CITY OF MADISON
CITY ENGINEERING DIVISION
DEPARTMENT OF PUBLIC WORKS
PLAN OF PROPOSED IMPROVEMENT
PHEASANT BRANCH GREENWAY ENHANCEMENT

CITY PROJECT NO. 14370

ADDENDUM #2
REVISED THE FOLLOWING:
SHEETS D1-D3
SHEETS EC1-EC4
SHEETS G13, G15, G112
SHEETS P1-P19, P21, P24-27
SHEETS U1-U18, U22
SHEETS E1-E6
SHEET PM1
SHEETS X32A-X34, X45-X48

REVISION 2
SHEET EC1-EC2
SHEETS P9, P13, P14
SHEETS U1, U5, U9, U11, U16, U19, U21
SHEETS X18-X19, X48

GREENWAY EAST SIDE TRAIL

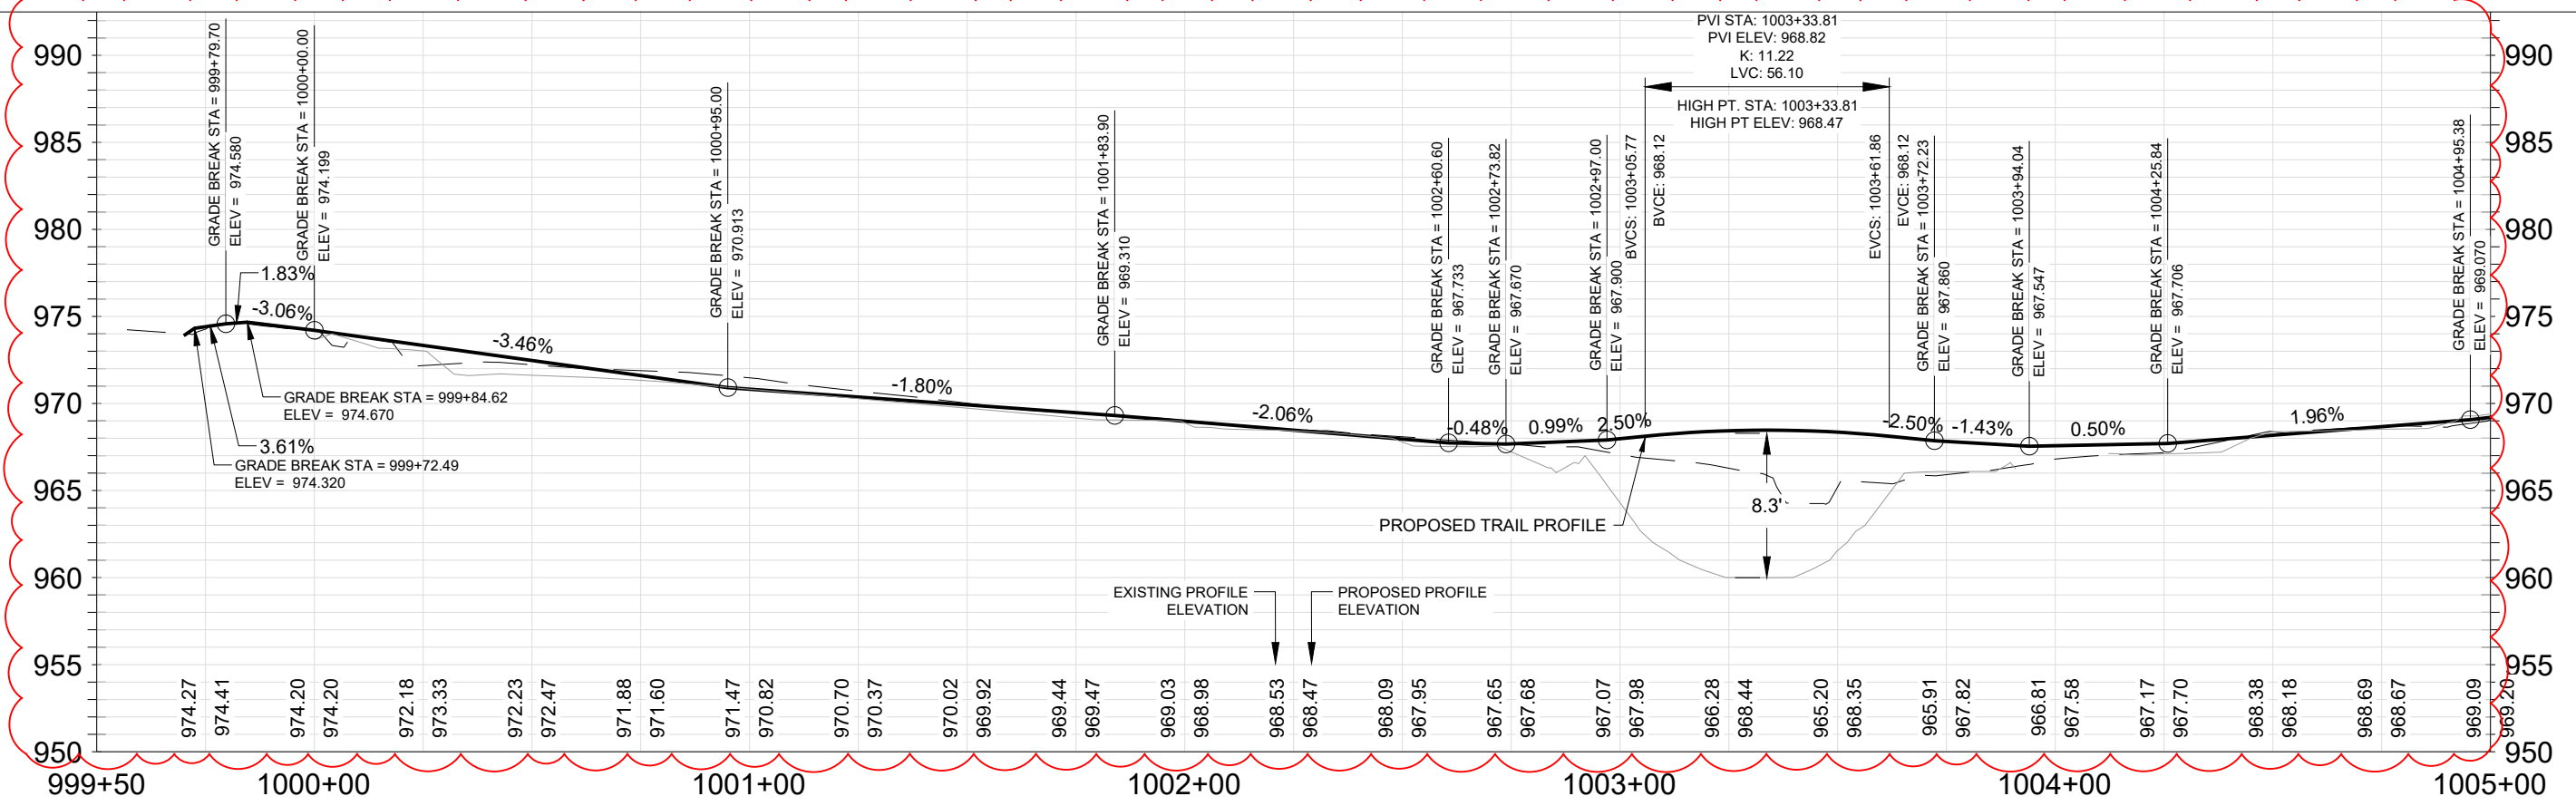
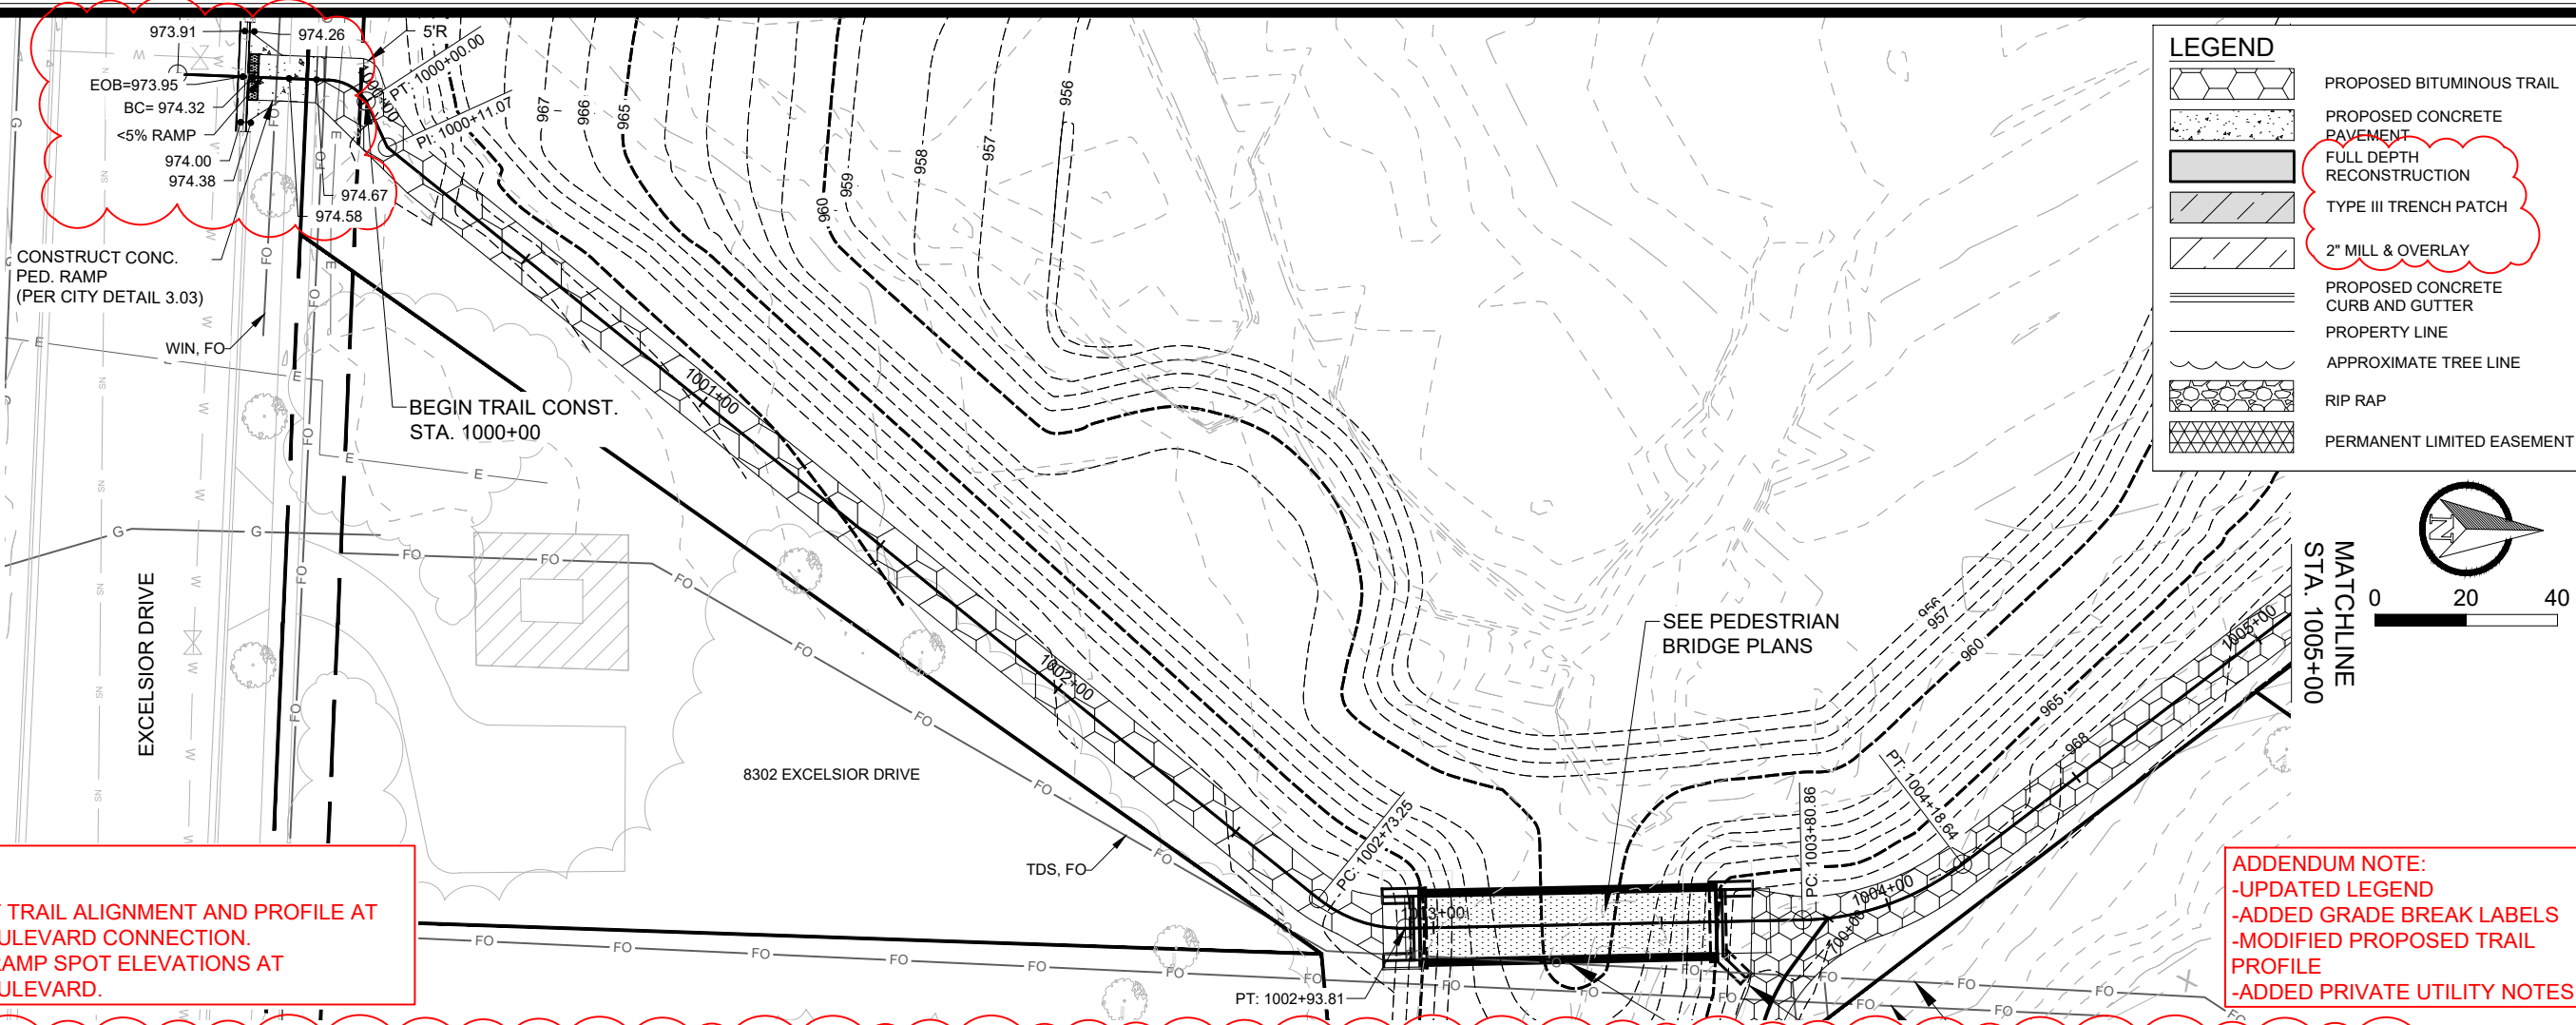
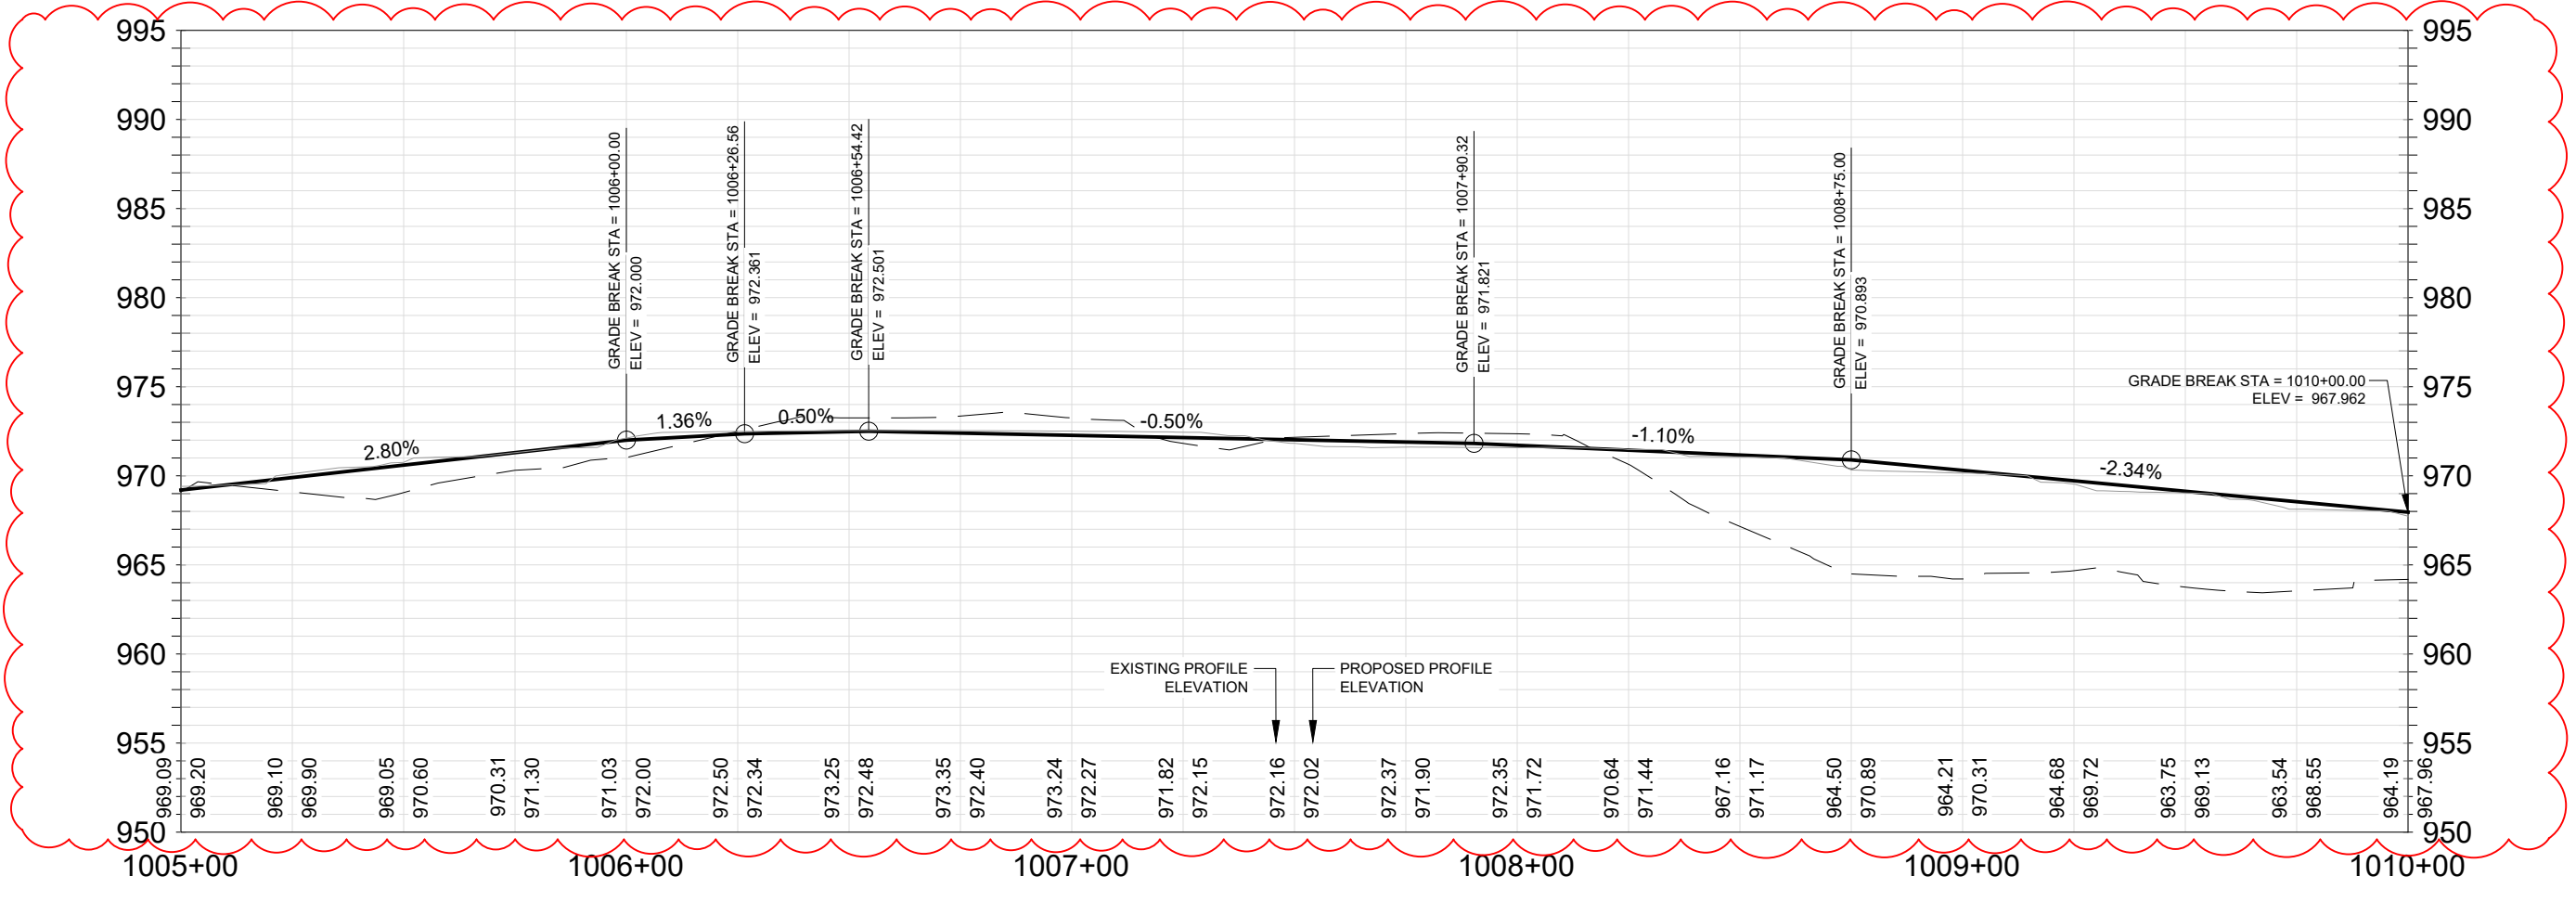
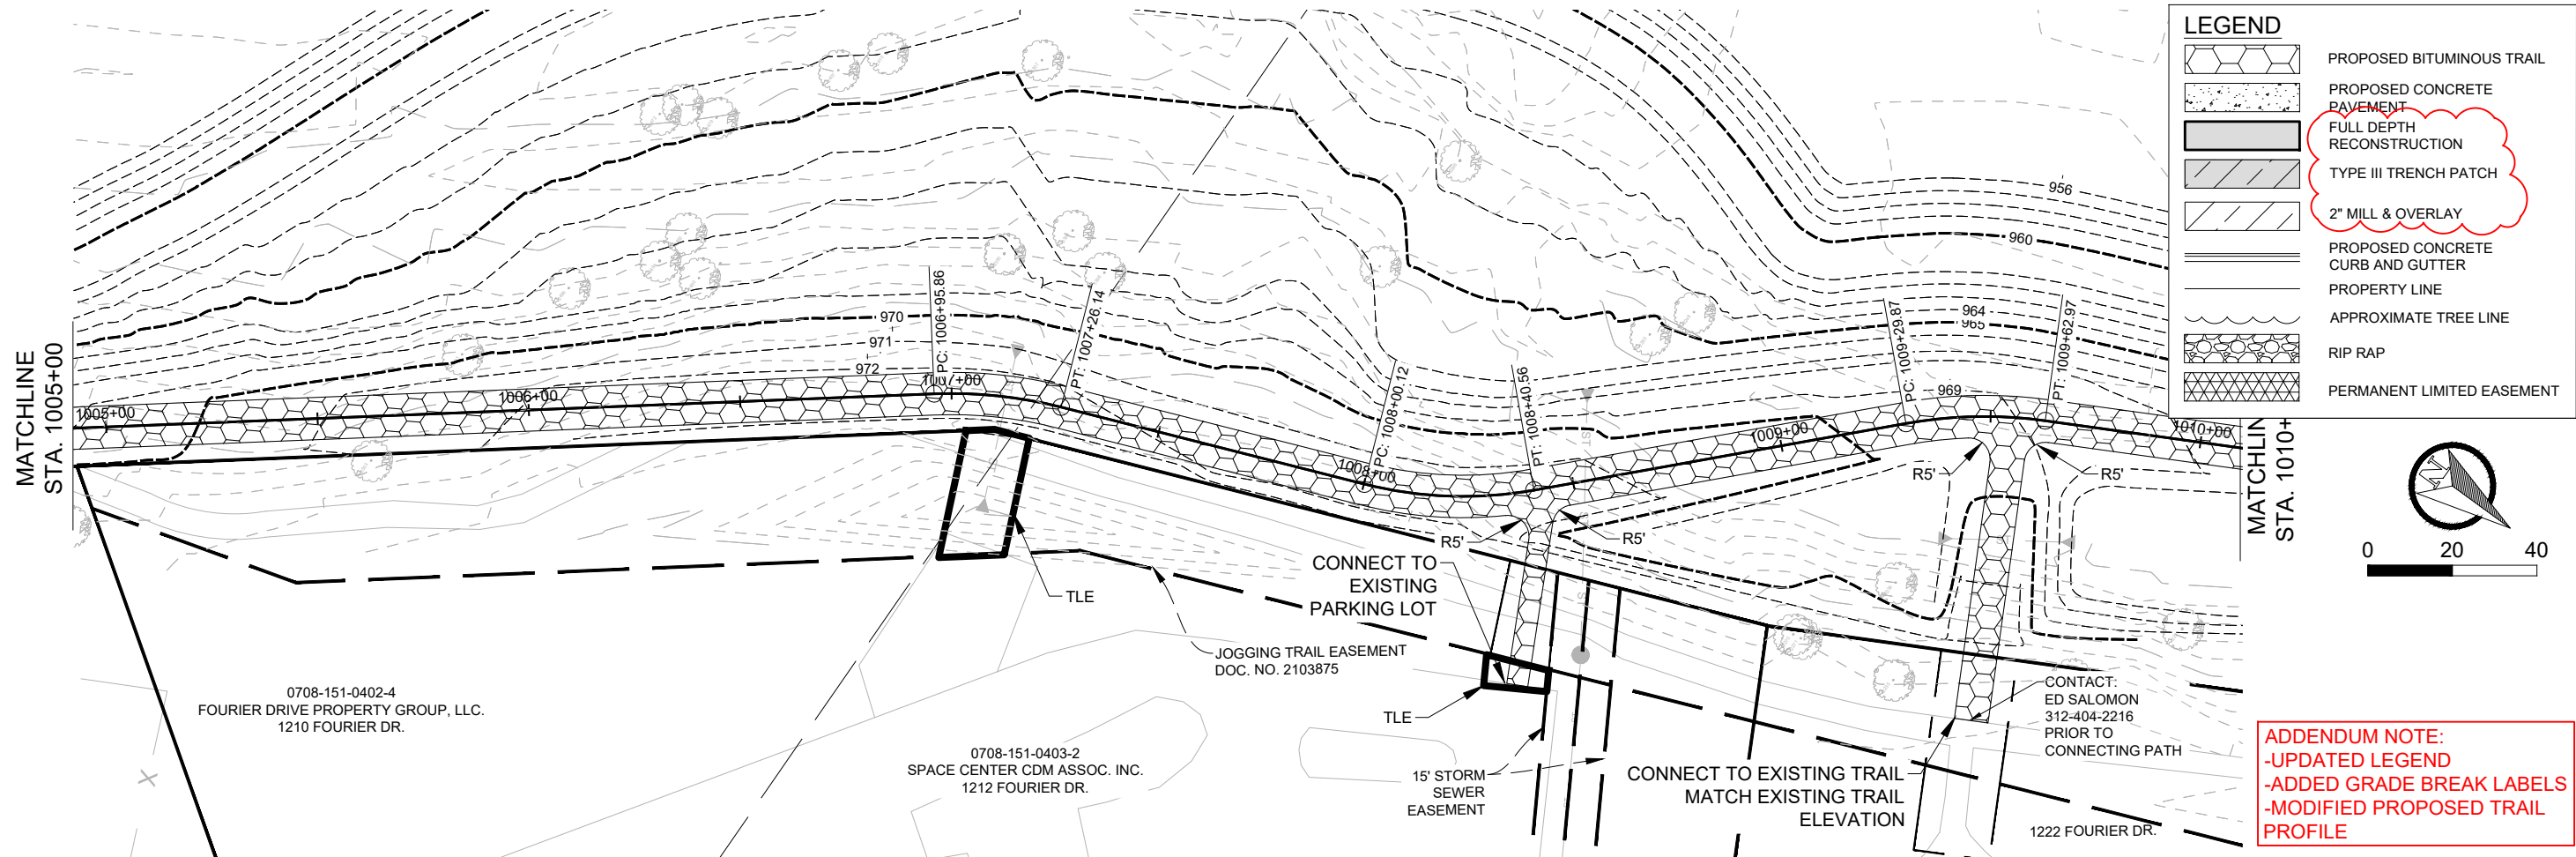
REVISION NO. 2

1. UPDATED EAST TRAIL ALIGNMENT AND PROFILE AT EXCELSIOR BOULEVARD CONNECTION.

2. ADDED CURB RAMP SPOT ELEVATIONS AT EXCELSIOR BOULEVARD.

U1

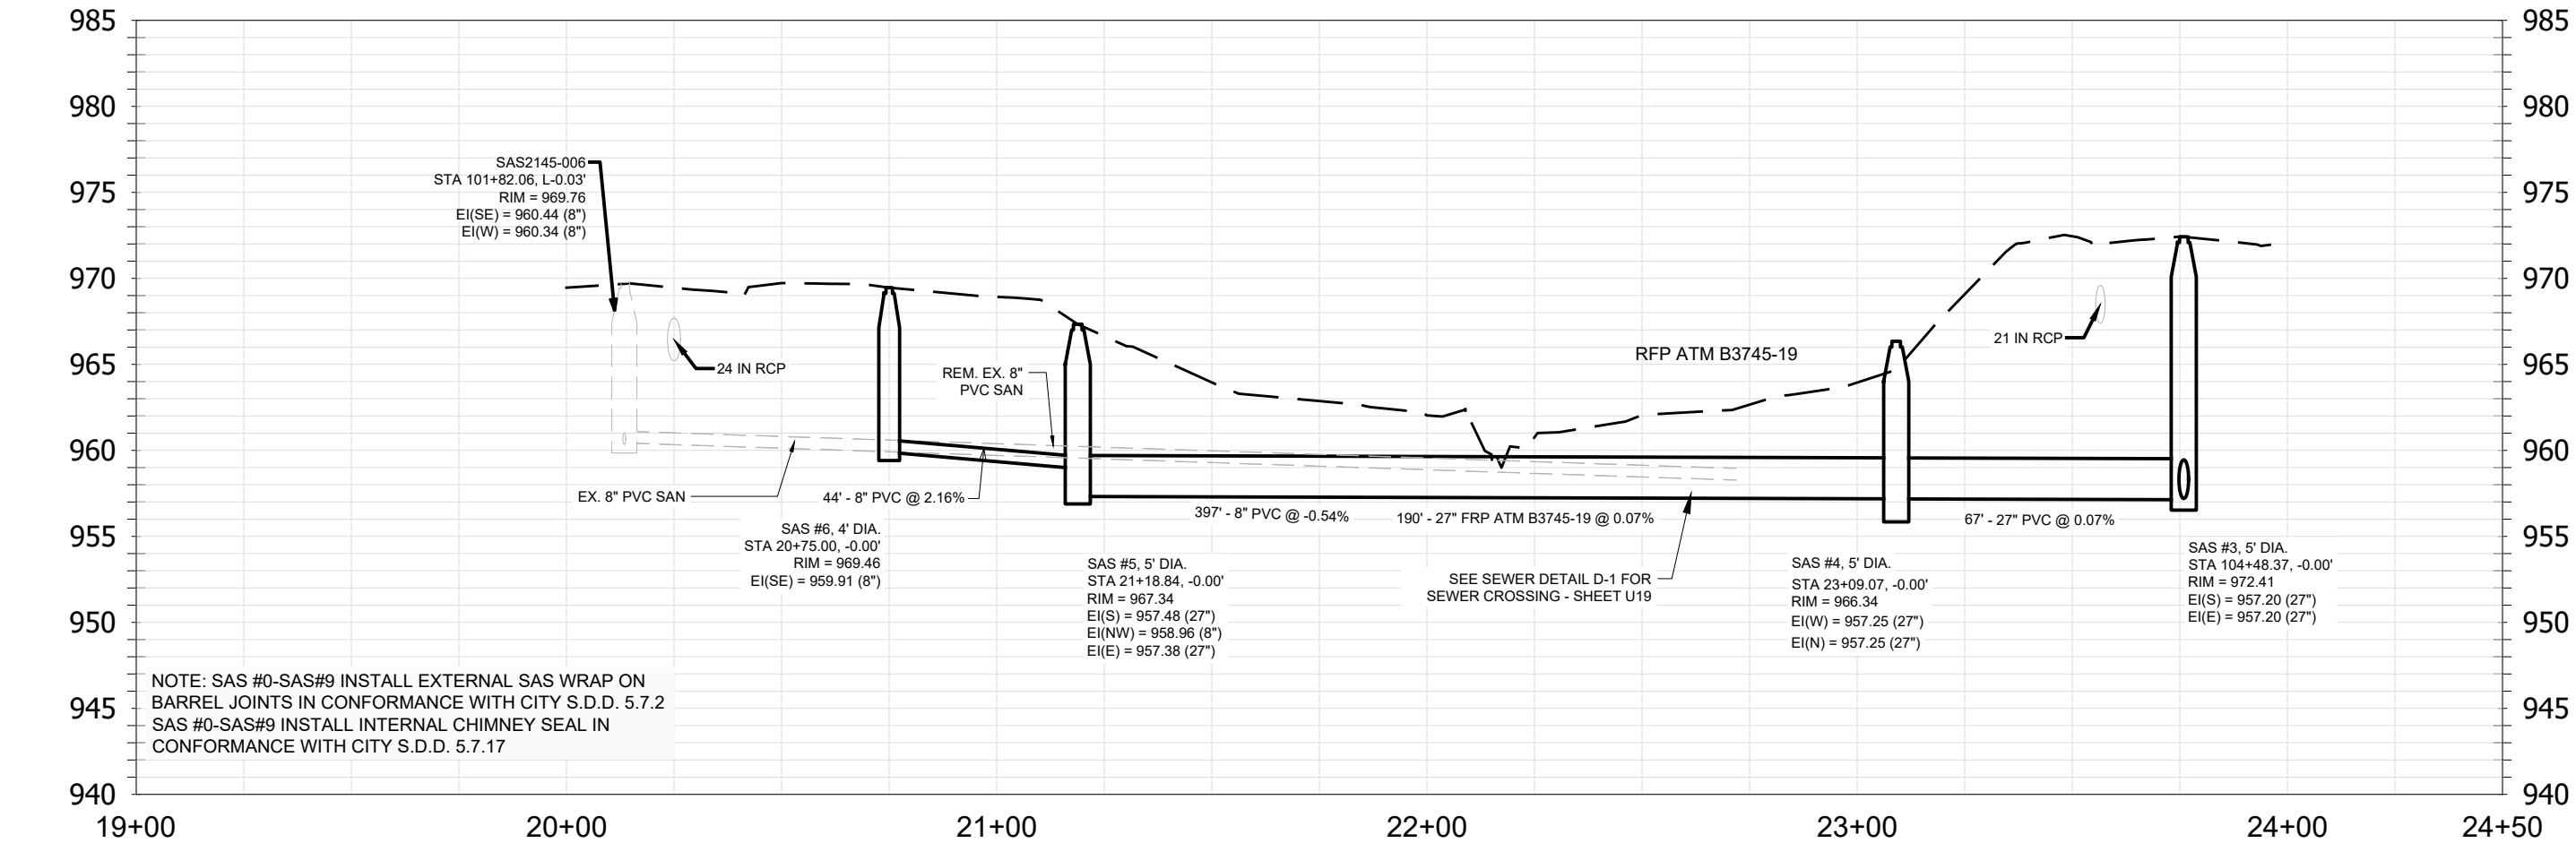
2	SANITARY SEWER REVISIONS	4/4/25	BB
	REVISION	DATE	BY
	Designed By: JPC	Date: 4/4/2025 1:51 PM	Scale: AS SHOWN
	14370		U1
